**SECTION 16 APPLICATION
TOWN PLANNING ORDINANCE (CHAPTER 131)**

**PROPOSED SOCIAL WELFARE FACILITY (RESIDENTIAL CARE HOME FOR THE ELDERLY) IN
“VILLAGE TYPE DEVELOPMENT” ZONE ON APPROVED NAM SANG WAI OUTLINE ZONING
PLAN NO. S/YL-NSW/10 AT LOTS 3670 RP (PART), 3671 RP (PART), 3672 RP (PART) AND 3673
RP (PART) IN D.D.104, NAM SANG WAI, YUEN LONG**

Town Planning Application No. A/YL-NSW/349 - Submission of Further Information (2)

PROPOSED SOCIAL WELFARE FACILITY (RESIDENTIAL CARE HOME FOR THE ELDERLY) IN “VILLAGE TYPE DEVELOPMENT” ZONE ON APPROVED NAM SANG WAI OUTLINE ZONING PLAN NO. S/YL-NSW/10 AT LOTS 3670 RP (PART), 3671 RP (PART), 3672 RP (PART) AND 3673 RP (PART) IN D.D.104, NAM SANG WAI, YUEN LONG
(Planning Application No. A/YL-NSW/349)
Response-to-Comment Table

Modification Plans of Noise Barrier and Street Furniture

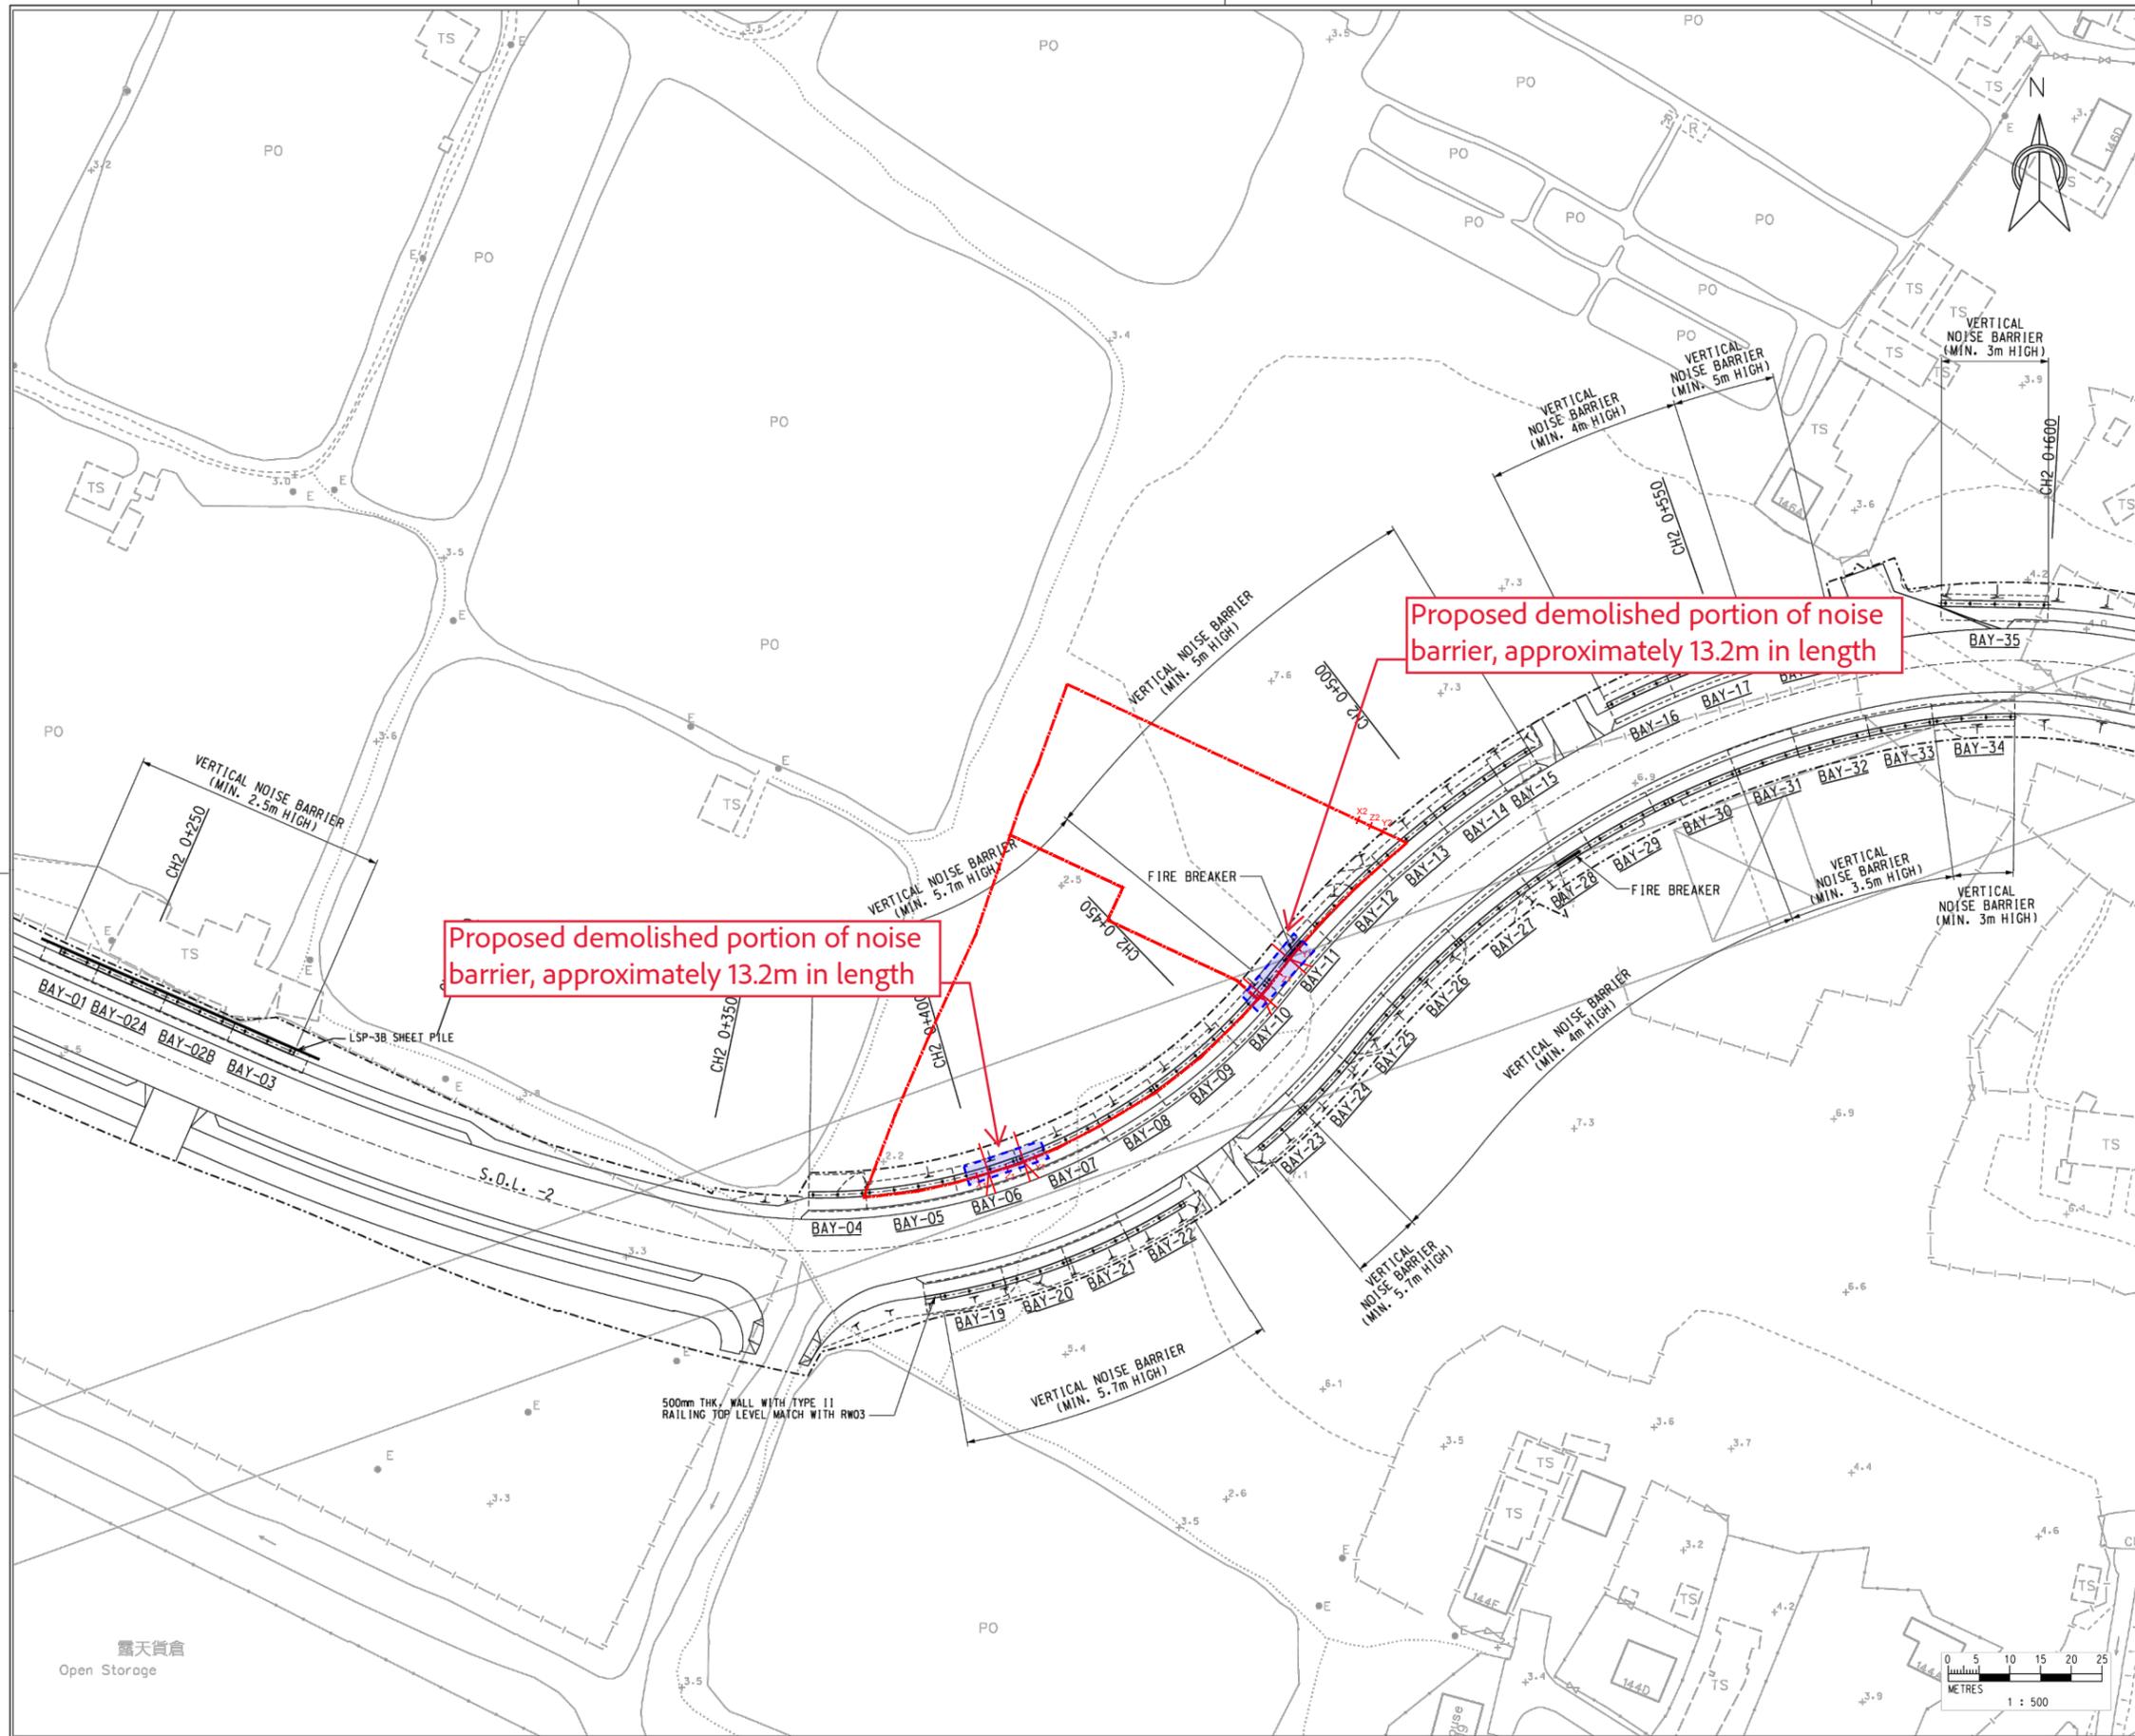
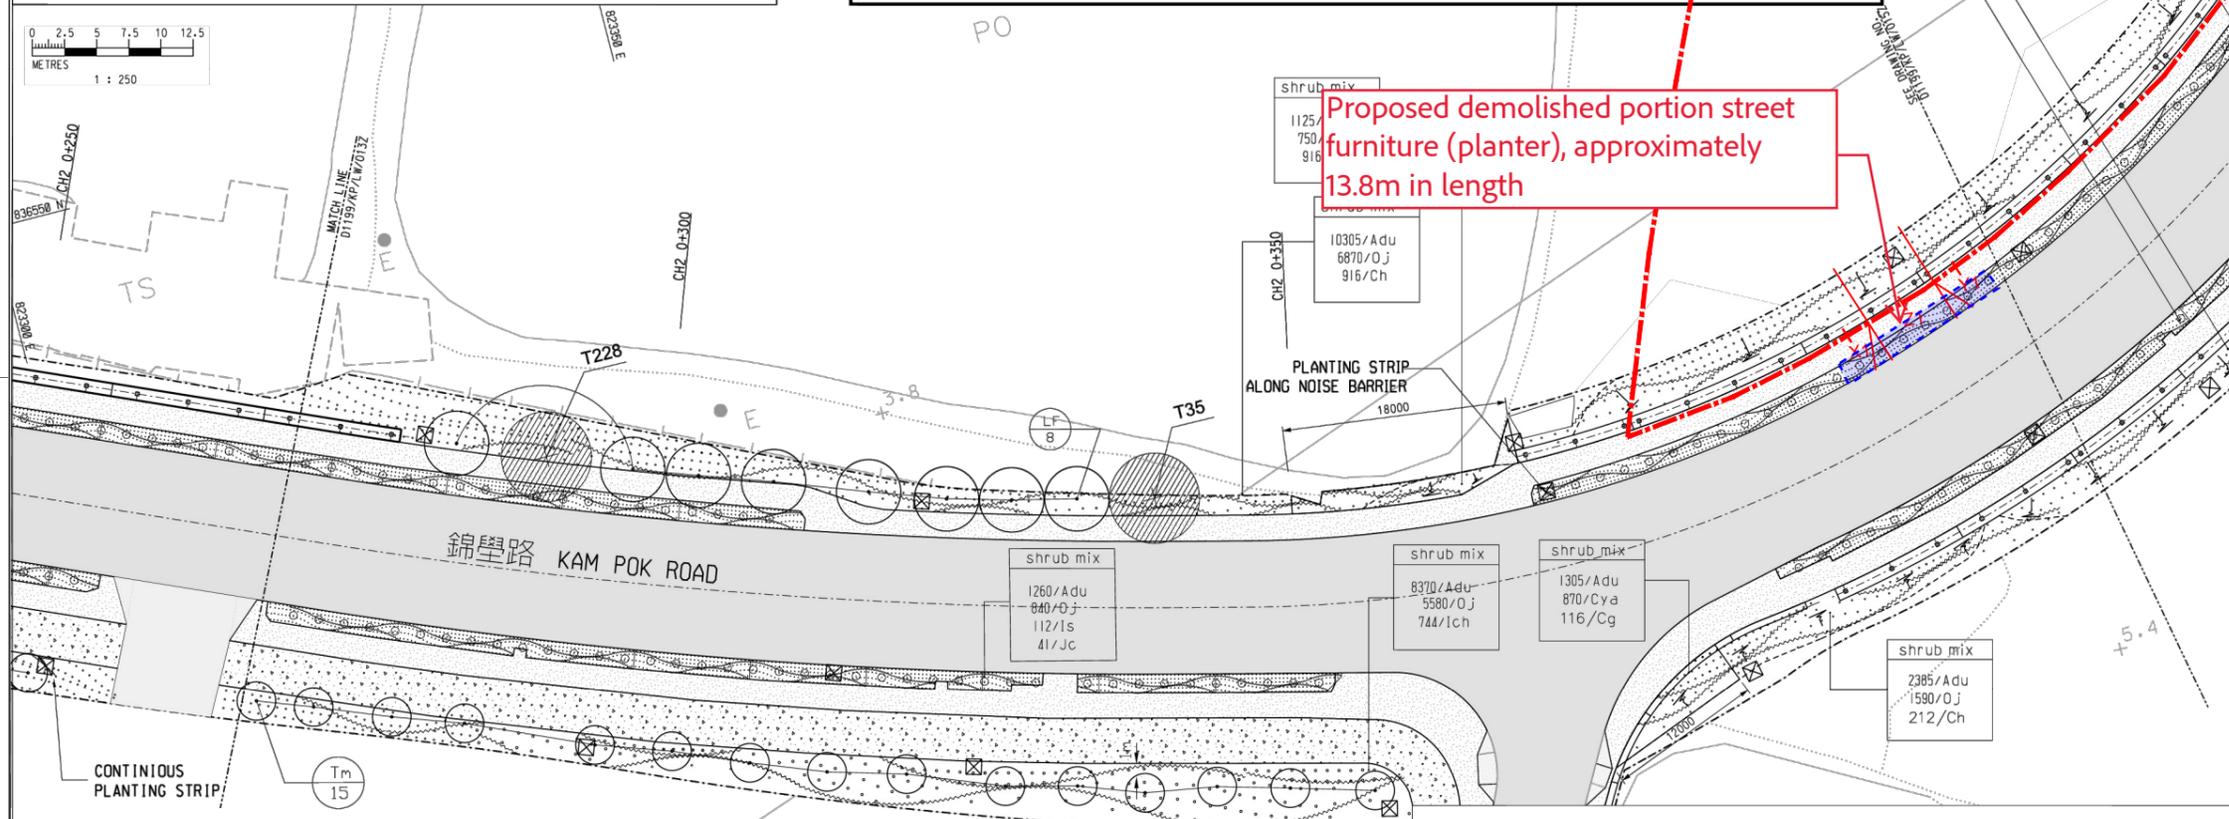
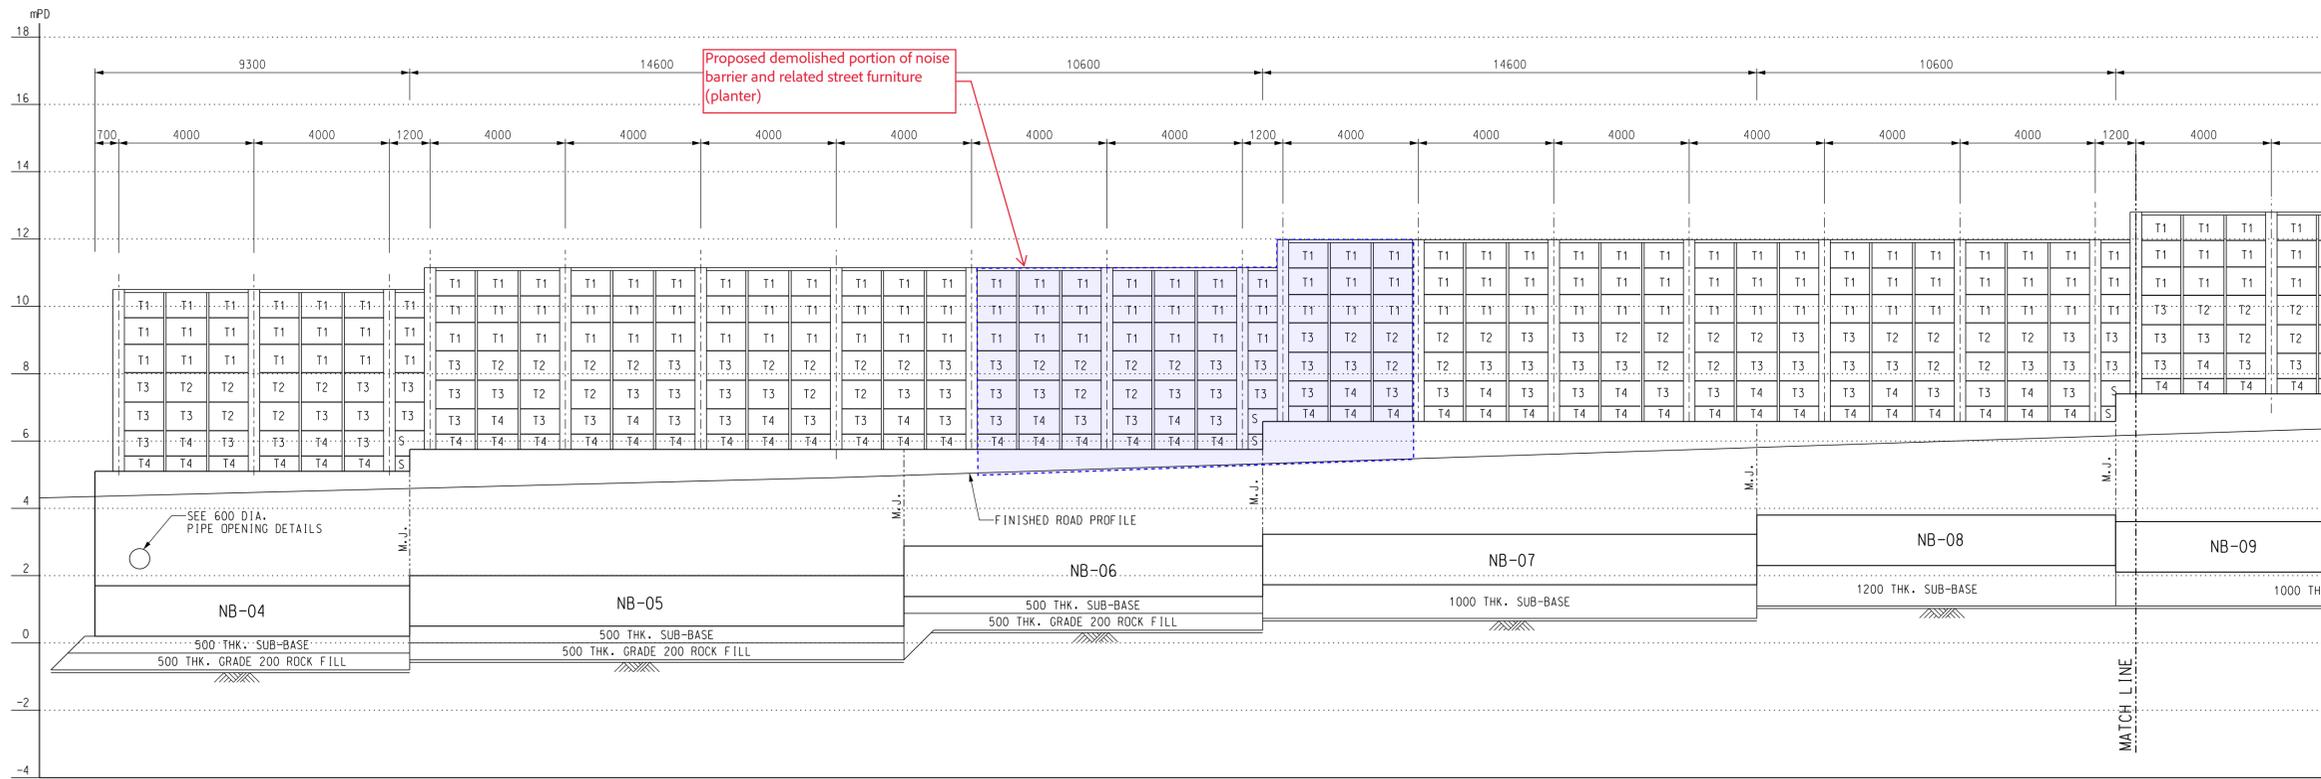
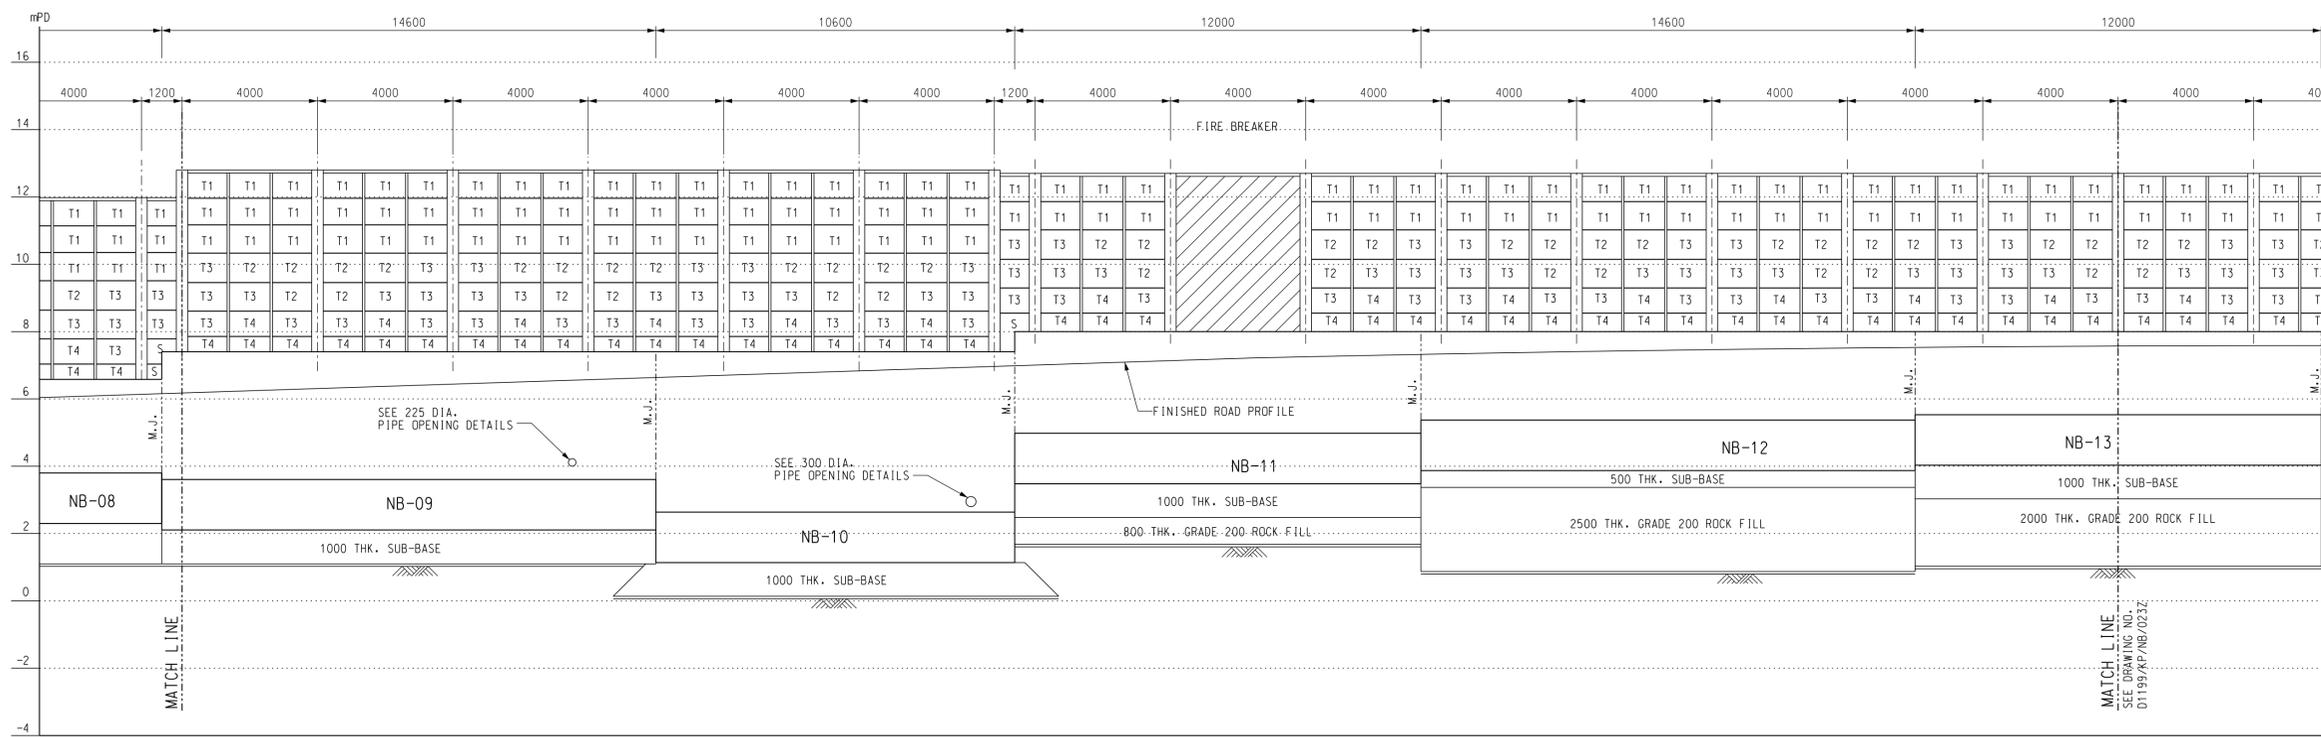
<p>2. There are breaks on the noise barrier in the model, please check, and revise if needed.</p>	<p>Refer to building plan in Appendix 3 of the revised EA (Appendix 1), part of the noise barrier will be removed for entrance of EVA.</p>
<p>3. Please provide information of the height of existing noise barrier, for our checking.</p>	<p>The height of existing noise barrier is obtained by site observation.</p>
<p>4. Texture depth is usually 1.2m, in the model it is 1.0m. Please check.</p>	<p>The texture depth is set to 1.2m accordingly.</p>
<p>5. Please check if the surface for the below segments at San Tin Highway, such as should it be bitumen instead of pervious?</p>	<p>Bitumen is set for the mentioned segments accordingly.</p>
<p>6. The speed limit for flow link 9 is 100 km/h. Only the zone refer to green coloured below is limited to 50 km/h, but it is located near the roundabout that outside 300m assessment area. Please check.</p>	<p>The speed limit for flow link 9 is set to 100 km/h accordingly.</p>

<ul style="list-style-type: none"> - Appendix 2: please specify the vehicular dimension (i.e. length and width) and driving speed adopted in the swept path analysis. Please adopt the largest possible vehicle that would enter the subject site in the swept path analysis; 	<p>Noted. Please refer to the Appendix 2 in the revised TIA (Appendix 2).</p>
<ul style="list-style-type: none"> - Please provide a plan to demonstrate sufficient sightline could be maintained at the proposed site access; 	<p>The measured length of visibility splay for the motorists leaving the Proposed RCHD is 60m to the left and 60m to the right, which is illustrated in Figure 3.3 in the revised TIA (Appendix 2).</p>
<ul style="list-style-type: none"> - There are noise barriers positioned at the proposed site access. Please provide details on the site access arrangement; 	<p>Portion of the existing noise barriers and related street furniture (planter) will be demolished for the proposed site access. Please refer to the Modification Plans of Noise Barrier and Street Furniture (Appendix 3) for the proposed alterations.</p>
